Independent Design Review:
Grants Chlorinated Solvents Plume
Superfund Site
Grants, Cibola County, New Mexico
EPA Region 6

Report of the Independent Design Review
Site Visit Conducted at the Grants Chlorinated Solvents Plume Superfund Site
August 1, 2007

Revised Report
June 4, 2008

Figure 1. Conceptual Cross-Section of Known Contaminant Extent and Targeted Areas for Remediation Specified in the ROD.

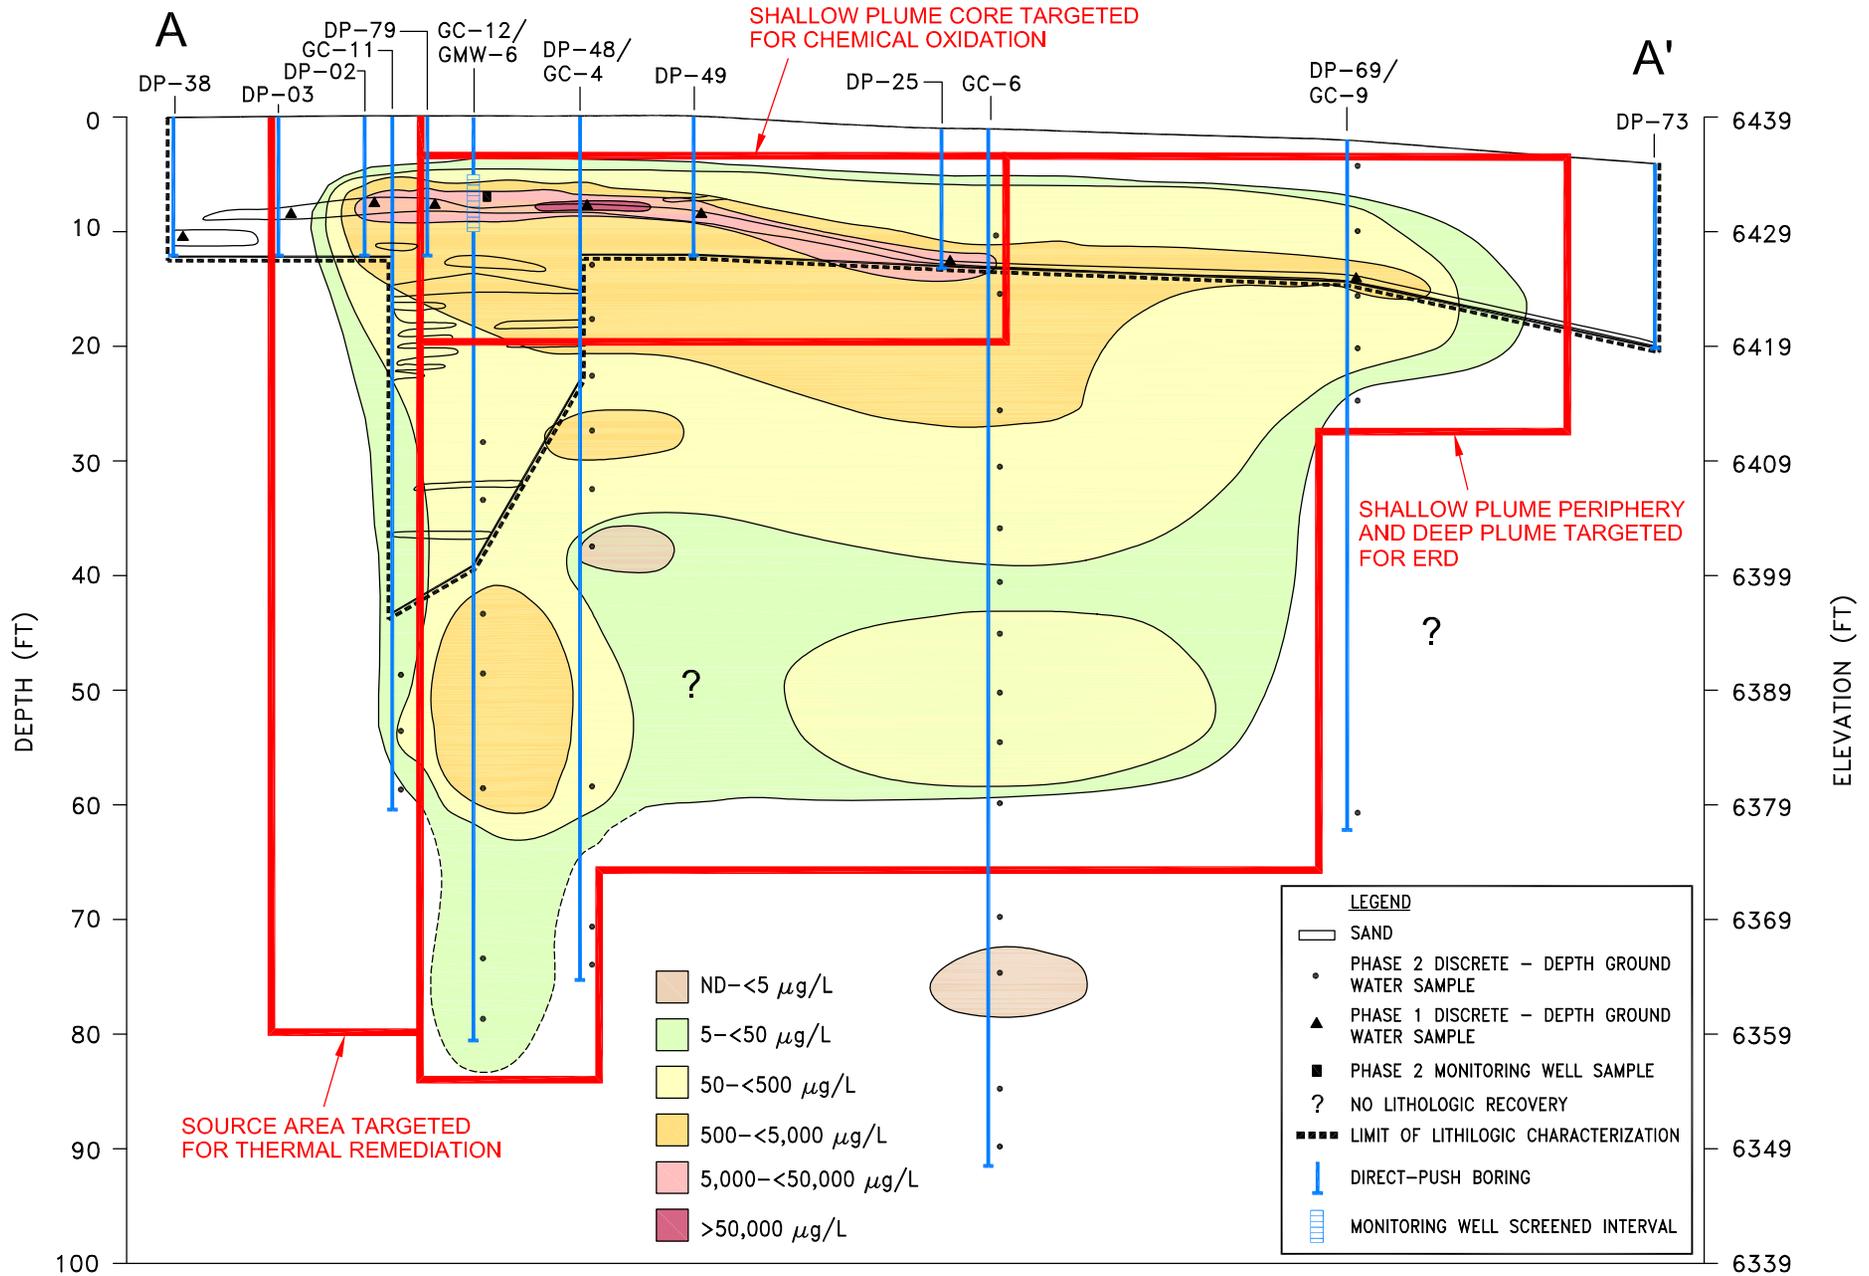
Figures 11 through 16 from the ROD illustrate the conceptual areas of implementation for these remedies, and **Figure 1** of this report illustrates a vertical cross-section of the target volume for the ground water remedies.

Figure 2. Proposed Soil Boring/Monitoring Well Locations.

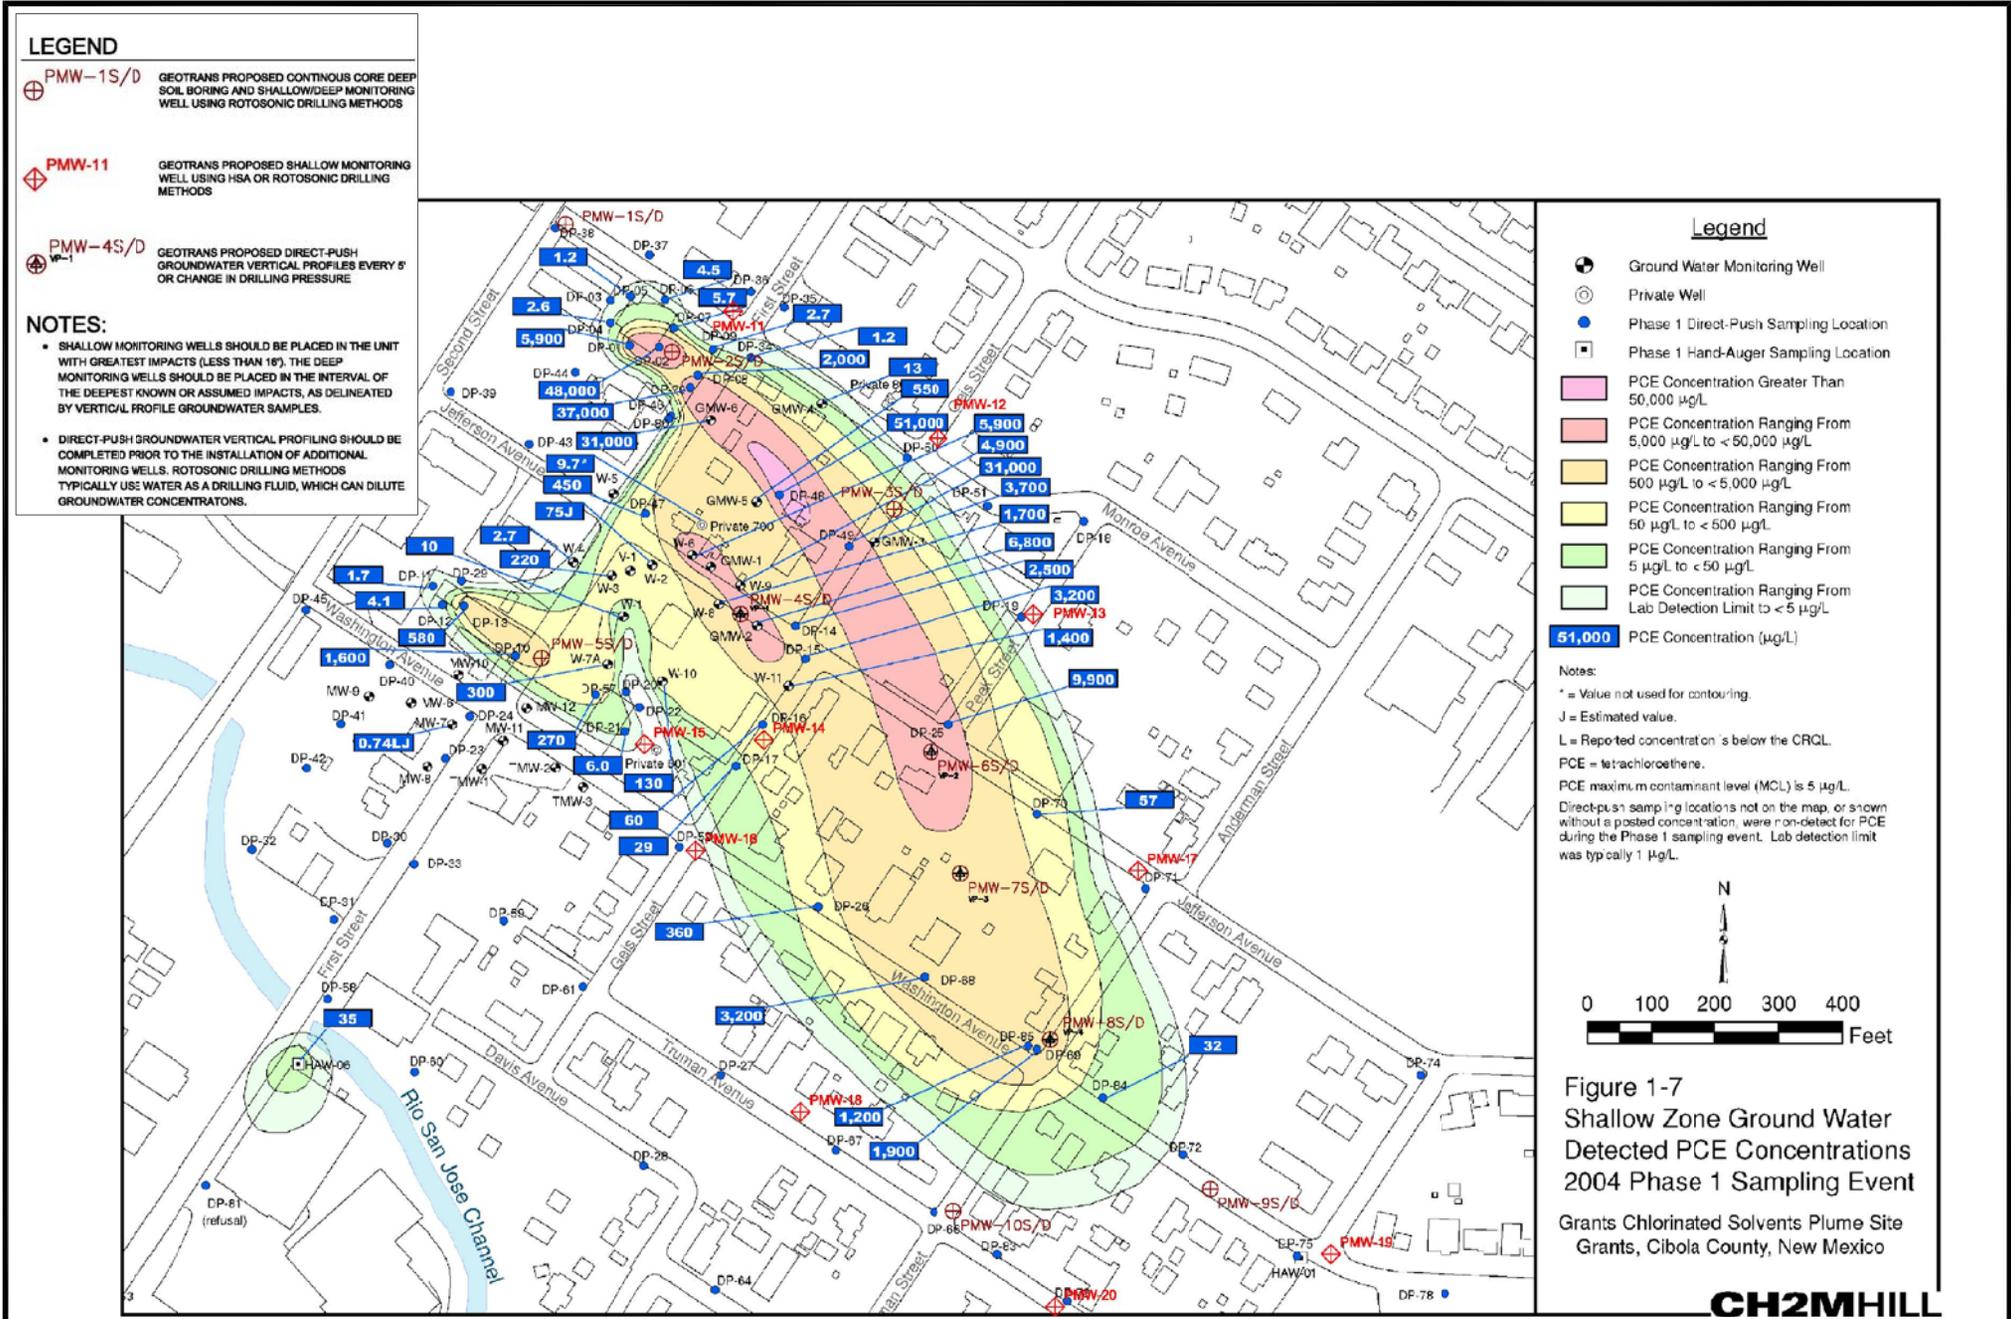
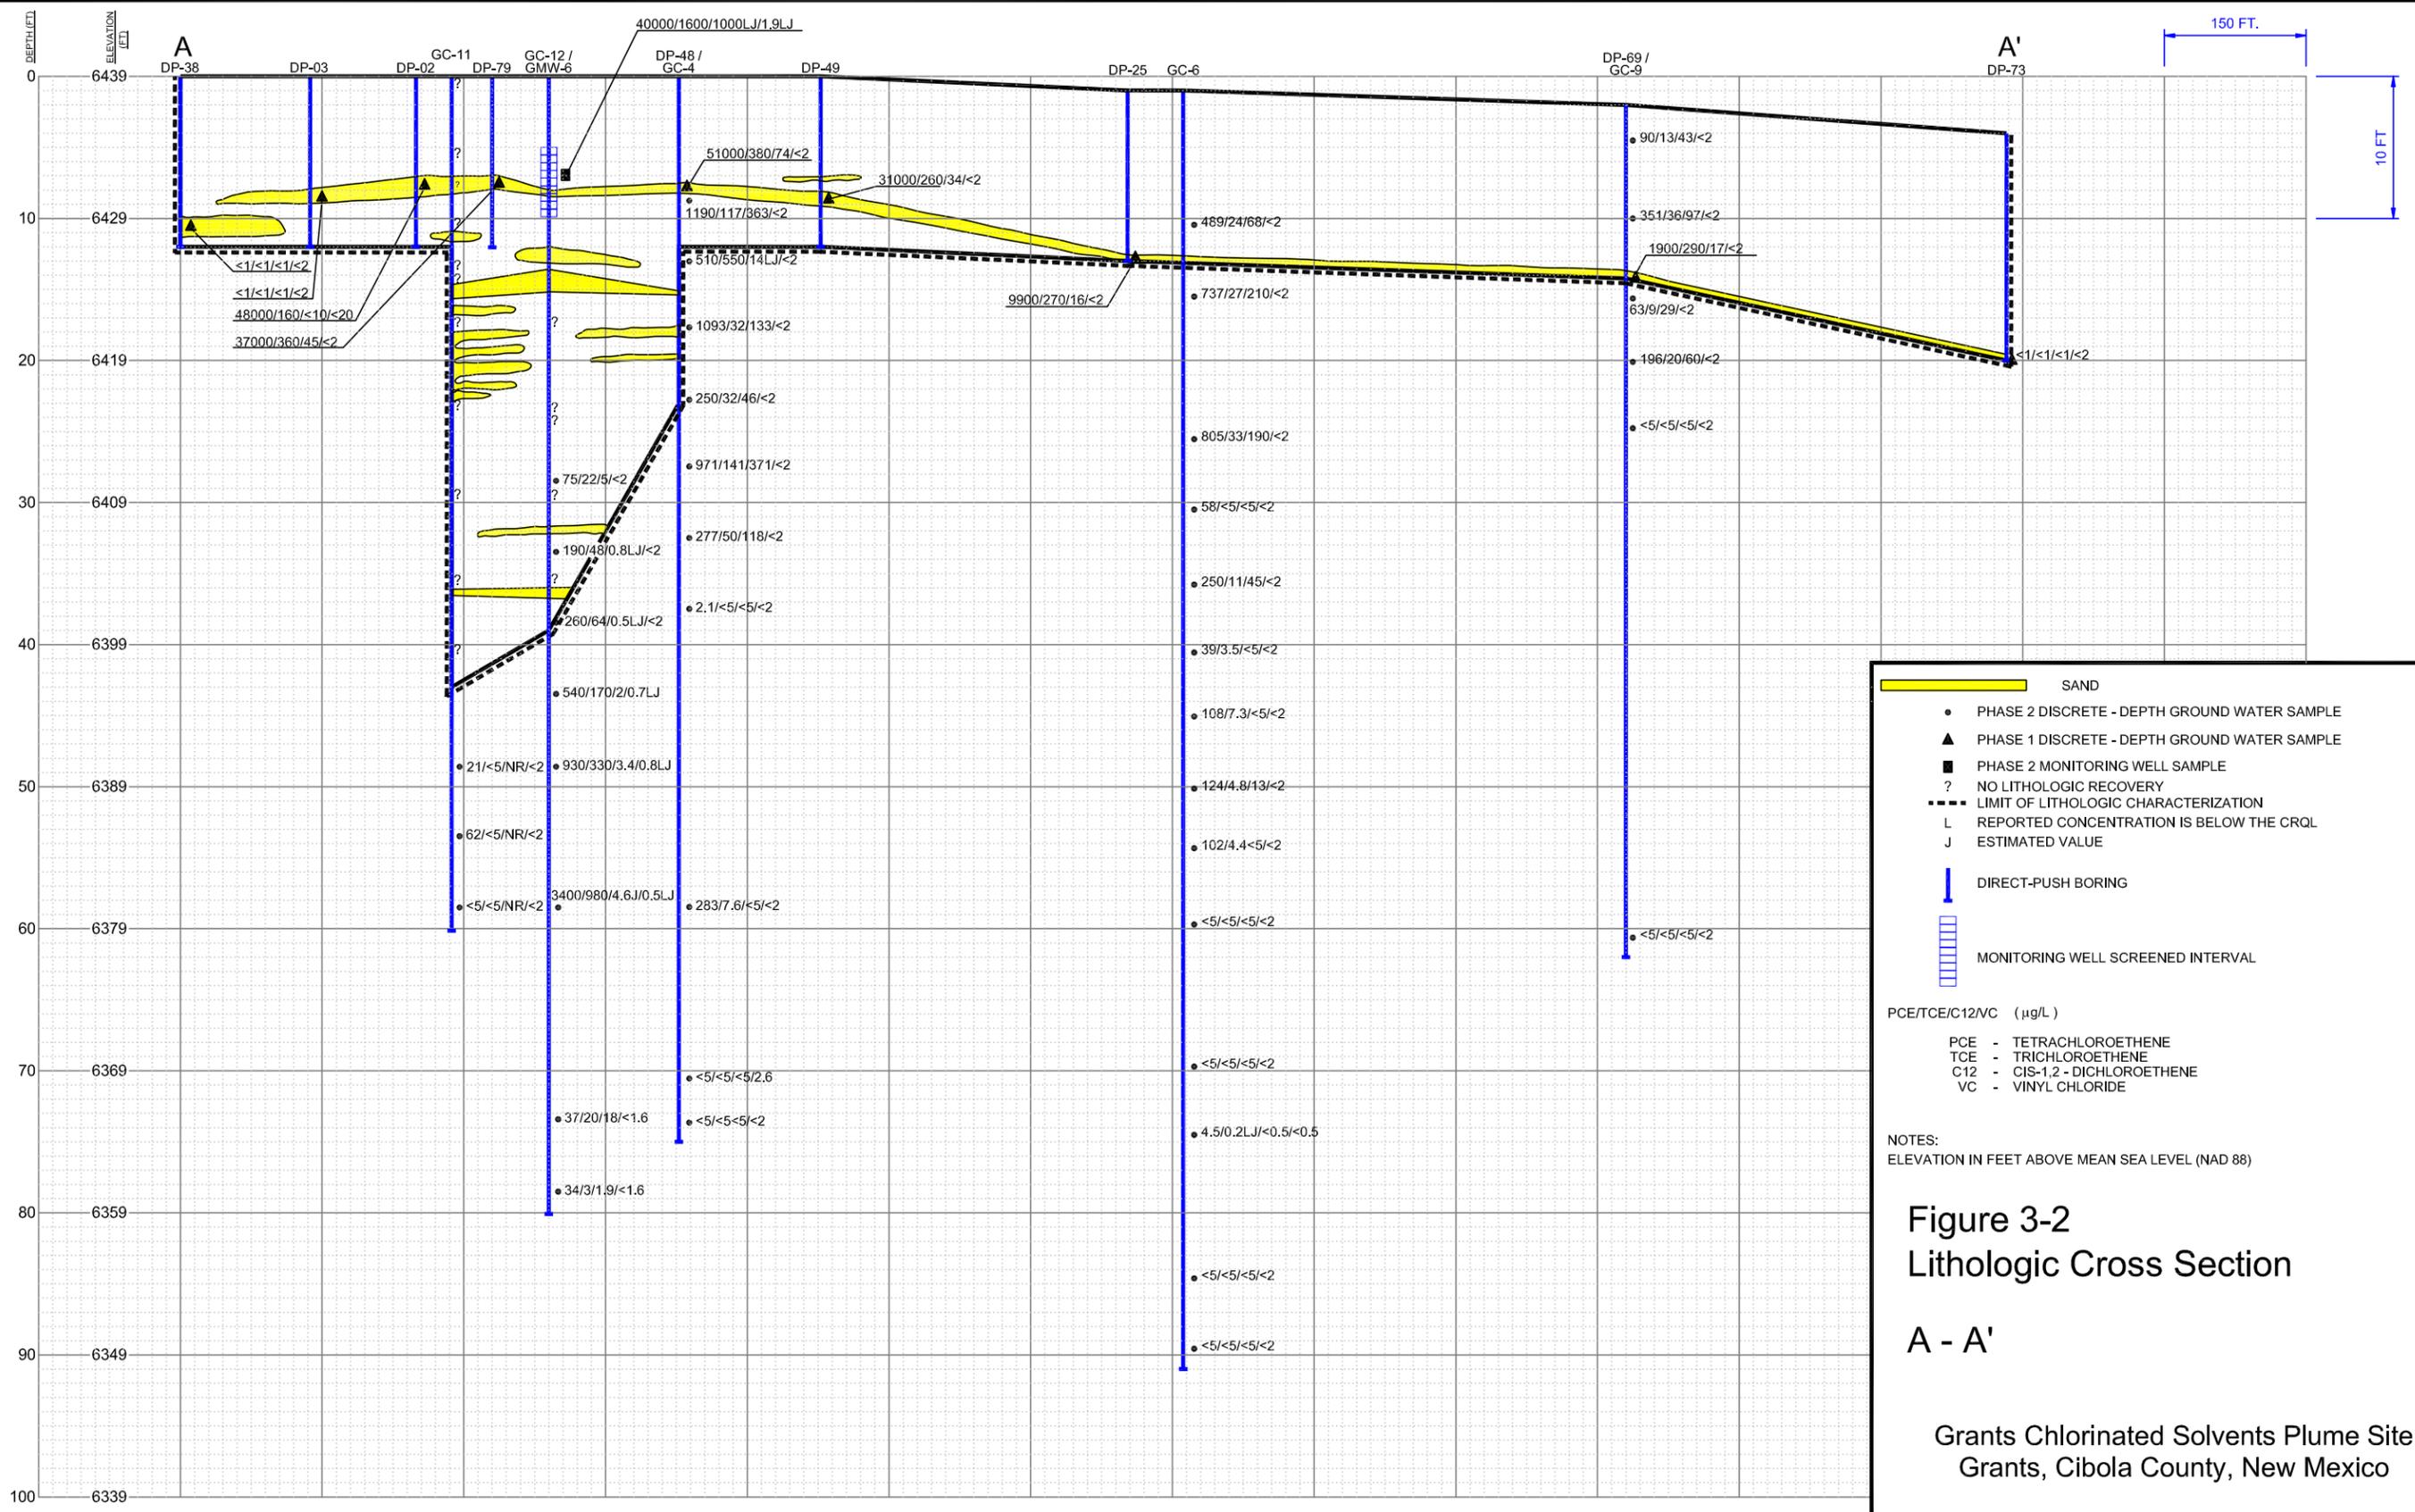
The IDR team agrees with the site team that multiple new monitoring wells are needed in multiple vertical zones. **Figure 2** proposes locations where the IDR team recommends installation of wells and the proposed screened intervals for those wells. The monitoring well locations are intended to provide an improved understanding of contaminant distribution and the site stratigraphy given that the thin transmissive zones can have a significant effect on remedial design considerations. The IDR team suggests that aquifer pumping tests be performed at PM-2S/D, PMW-4S/D and PMW-6S/D to better determine the site hydraulic conditions and to determine whether site water could be used as an alternative to municipal water.
